Access Compliance Report Public Rights-of-Way (Curb Ramps)

Main Street: KEMPTON_DR Cross Street: OAK_LEAF_DR Location: NW

ADA ID: RPRK211221130942 Ramp Type: Type 1 - Perpendicular Diagonal Initial Pass/Fail: Fail Overall Compliance: No Severity Score: 15

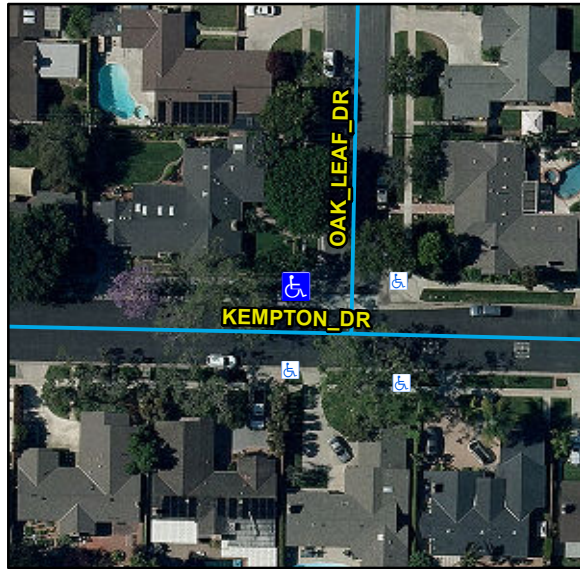
Compliance	Description	Data	Compliance	Description	Data
N/A	Ramp Length (in)	94	N/A	Flare Type LT	
Yes	Ramp Width (in)	54			N/A
No	Ramp Run Slope (%)	8.5	N/A	Flare Slope LT (%)	N/A
Yes	Ramp Cross Slope (%)	0.3	N/A	Flare Traversable LT	N/A
N/A	Landing Present	N/A	N/A	Flare Type RT	
N/A	Landing Length (in)	N/A			N/A
N/A	Landing Width (in)	N/A	N/A	Flare Slope RT (%)	N/A
N/A	Landing Run Slope (%)	N/A	N/A	Flare Traversable RT	N/A
N/A	Landing Cross Slope (%)	N/A	N/A	DWS Provided	N/A
N/A	Landing Movement Obstructed?	N/A	N/A	DWS Contrast	N/A
	Landing Movement Type	N/A	N/A	DWS Length (in)	N/A
N/A	Landing Shared	N/A	N/A	DWS Full Width	N/A
N/A	Clear Space	Yes	N/A	DWS Offset Left (in)	N/A
N/A	Clear Space To Crosswalk (in)	N/A	N/A	DWS Offset Right (in)	N/A
N/A	Marked Crosswalk 1	No	N/A	Marked Crosswalk 2	No
	Crossing 1 Direction	S		Crossing 2 Direction	E
	Marked Crosswalk 1 Width (in)	N/A		Marked Crosswalk 2 Width (in)	N/A

Remove & Replace Curb Ramp With Two New Directional Ramps or Equivalent.
